**PCN# 20140218000  
Design Revision (NBTI Fix for Select TPS4005x Devices)  
Change Notification / Sample Request**

**Date:** 2/20/2014  
**To:** MOUSER PCN

Sample product shipping label to indicate die rev location (**not actual product label**)

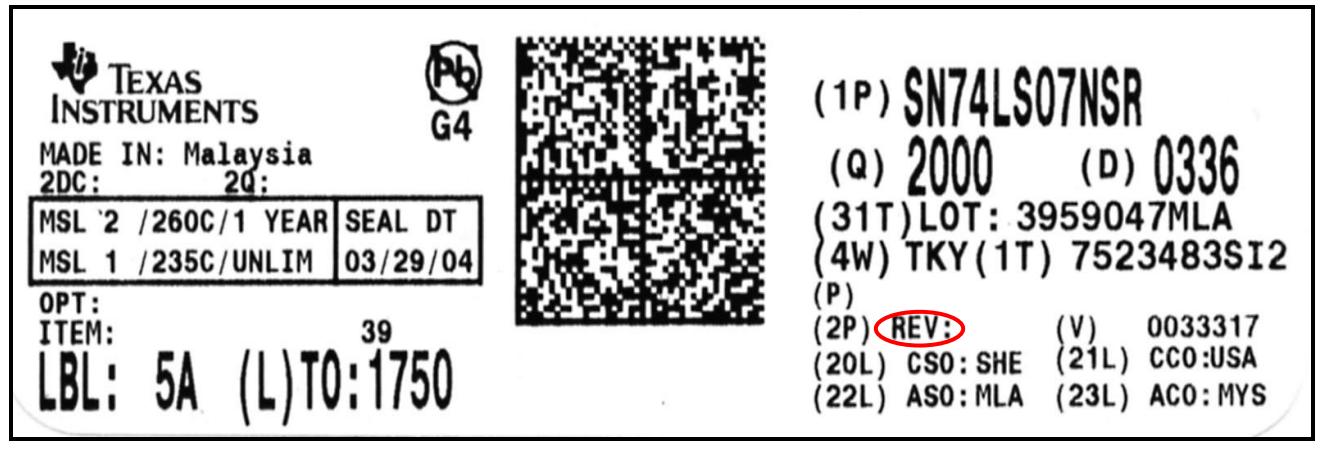
**Die Rev designator will change as shown in table & sample label below:**

Current	New
Die Rev [2P]	Die Rev [2P]
A	C
